Access Compliance Report

Public Rights-of-Way

Intersection ID: 20057	Main Street: ASSEMBLY_ST	Cross Street: BULFINCH_RD	Location: NW
ADA ID: 7B6A50EE4C0F	Ramp Type: BlendTrans1	Initial Pass/Fail: Pass	Overall Compliance: No
		Severity Score: 0.25

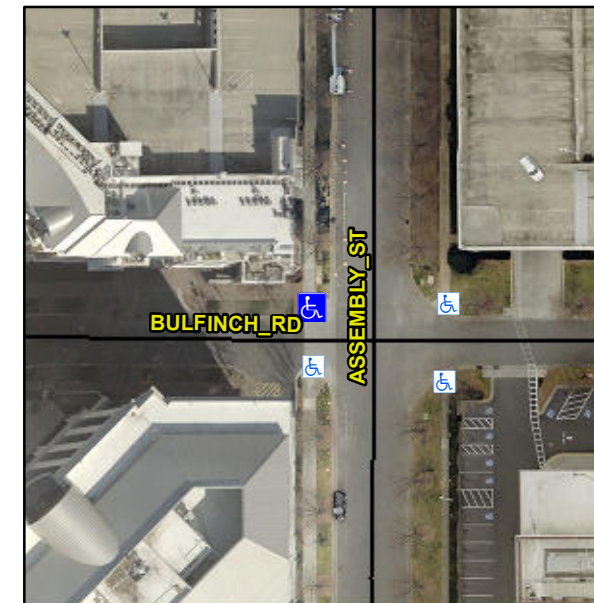
Remove & Replace Curb Ramp With Two New Directional Ramps or Equivalent. Remove & Replace Gutter.

R304.5.3, R304.2.2-Perp, R304.3.2-Para

Compliance	Description	Data	Compliance	Description	Data
N/A	Ramp Length (in)	145.0	Yes	BlendTrans Slope (%)	2.2
Yes	Ramp Width (in)	48.0	No	BlendTrans XSlope (%)	3.0
N/A	Flare Type LT	Sloped	N/A	Flare Type RT	Sloped
N/A	Flare Slope LT (%)	2.6	N/A	Flare Slope RT (%)	0.2
N/A	Flare Traversable LT?	No	N/A	Flare Traversable RT?	No
Yes	Landing Length (in)	70.5	Yes	DWS Provided?	Yes
Yes	Landing Width (in)	71.0	Yes	DWS Contrast?	Yes
No	Landing Slope (%)	2.5	Yes	DWS Length (in)	24.0
Yes	Landing X Slope (%)	0.2	Yes	DWS Full Width?	Yes
N/A	Landing Curb? (Y/N)	No	Yes	DWS Offset (in)	1.0
N/A	Shared Landing?	No			
Yes	Gutter Ponding?	No	Yes	Gutter Slope (%)	2.2
Yes	Gutter Lip Ht (in)	0.0	No	Gutter X Slope (%)	2.2
N/A	Painted X Walk1?	No	N/A	Painted X Walk2?	No
	X Walk 1 Direction	To S		X Walk 2 Direction	To E
	X Walk 1 Width (in)	N/A		X Walk 2 Width (in)	N/A
	X Walk 1 Slope (%)	1.0		X Walk 2 Slope (%)	0.1
	X Walk 1 X Slope (%)	2.4		X Walk 2 X Slope (%)	2.7
